*issues***MANDATORY BULLETIN No. Harmony-006a**

- 1. CONCERNING:** All Harmony aircraft up to S/N 2025 2252 inclusive.
- 2. REASON:** Foot control pedal assembly without a weld reinforcement on countershaft may have been installed in some of the Harmony aircraft.

Fig. 1 Locations of pedal assembly welded reinforcements

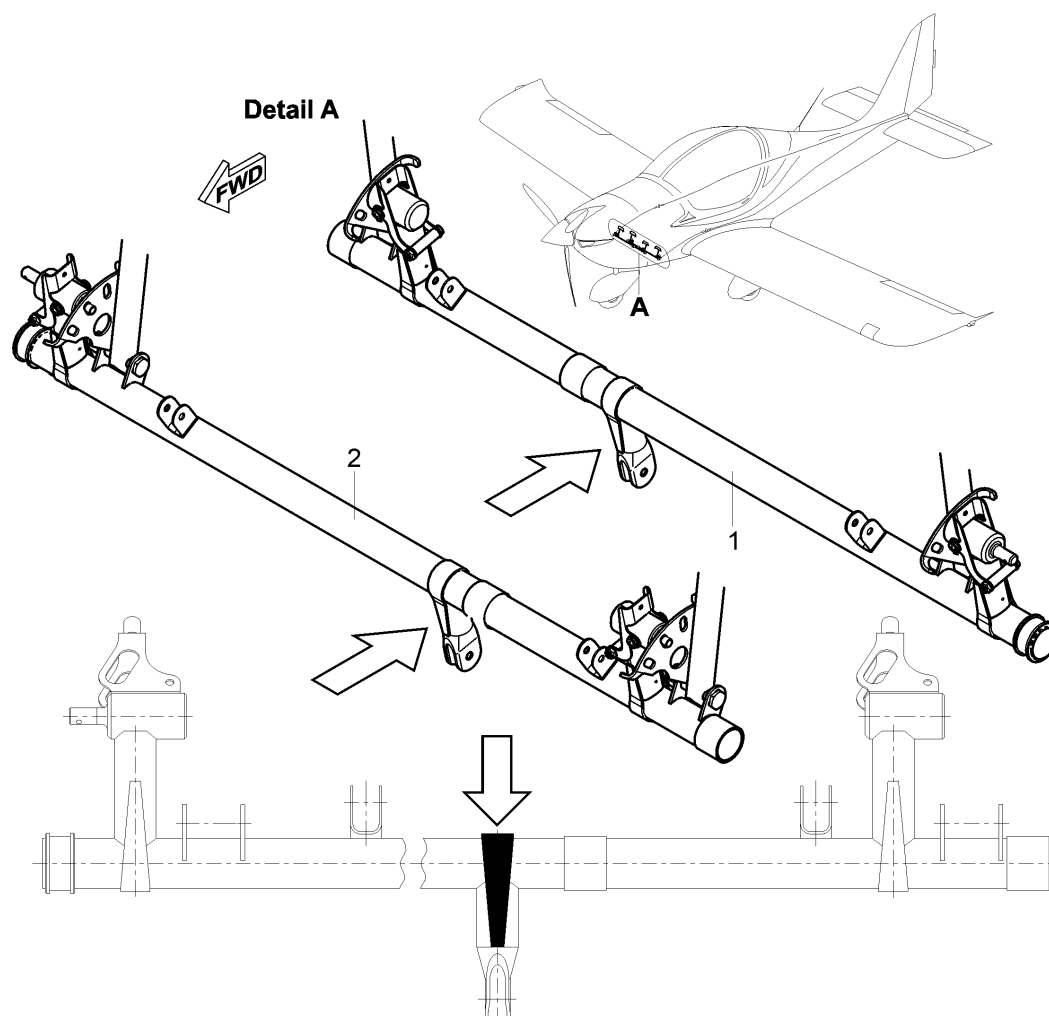
- 3.1.1 Examine whether both foot pedal control assemblies (P/N S4 72-01 01/02 or S4 70-02 01/02, if installed) include the weld reinforcement on the welded connection of countershaft tube (1, 2, Fig. 1) and lever. See Fig. 1 and Fig. 2 for welded reinforcement locations.
- 3.1.2 If the weld reinforcements are missing, take a photo of affected part(s) and report the inspection results to the manufacturer by submitting an Aircraft Occurrence Technical Report, including the photos of the affected part(s).
- 3.1.3 If the weld reinforcements are missing, replace the original countershafts of the foot control pedal assembly with the new countershafts with the weld reinforcement (P/N S4 72-01 01/02 or S4 70-02 01/02) in accordance with Work procedure para. 3.2 and 3.3.

Make sure you use the correct countershaft as replacement. Identify the P/N of the original countershaft without the weld reinforcement and use the new countershaft with the weld reinforcement, and with the same P/N as the original countershaft, as replacement:

- The foot control pedal assembly, equipped with remote position control, includes countershafts P/N S4 72-01 01/02.
- The foot control pedal assembly, without remote position control, includes countershafts P/N S4 70-02 01/02.

Fig. 2 (a+b) Detail of Countershaft Left with/without the weld reinforcement

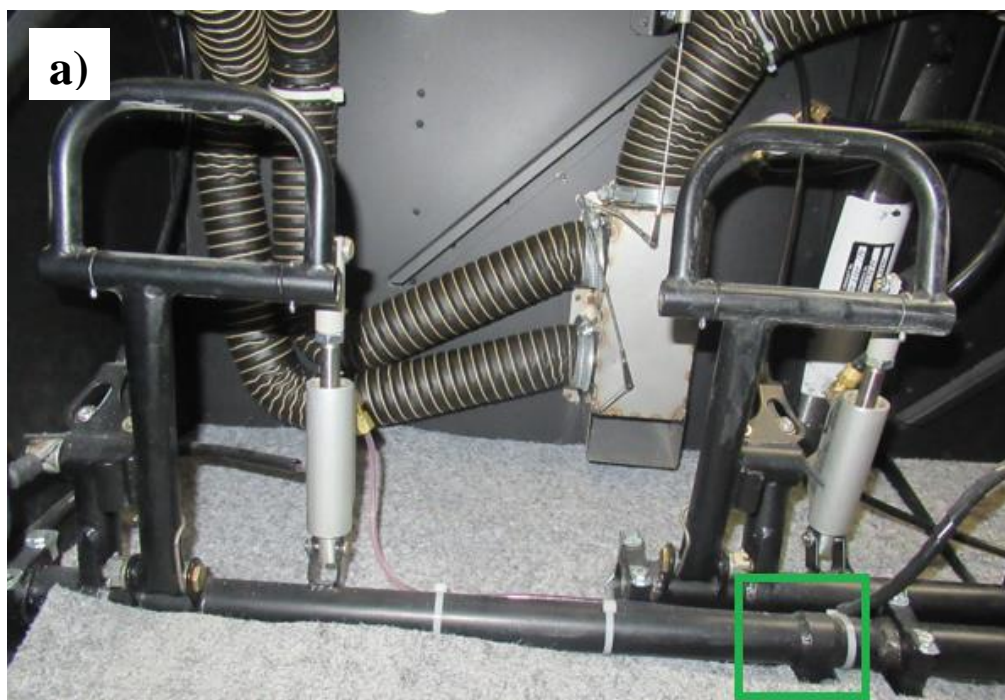
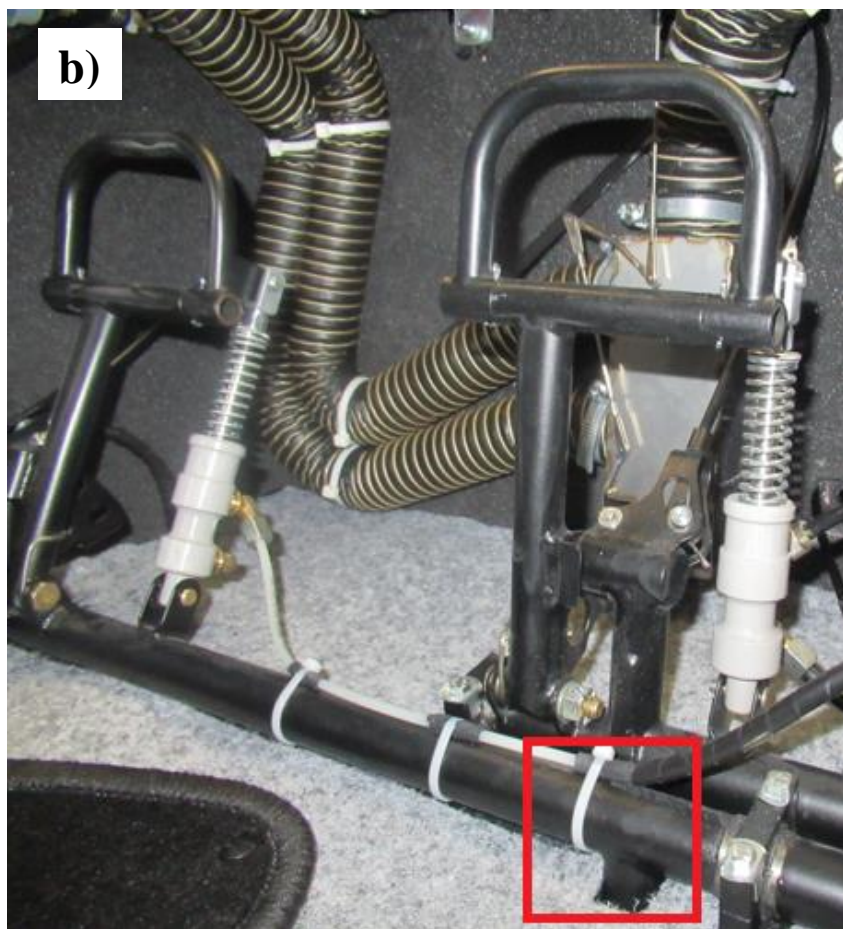
2. If the weld reinforcement is missing, examine the welded connection of the countershaft tube and the lever for cracks.
 3. If the weld reinforcement is missing, replace the original countershaft (P/N S4 72-01 01/02 or S4 70-02 01/02, if installed) with the new countershaft with the weld reinforcement, in accordance with the work procedure of this bulletin.

a) Countershaft tube and lever welded connection with the weld reinforcement (green square)

b) Countershaft tube and lever welded connection without the weld reinforcement (red square)
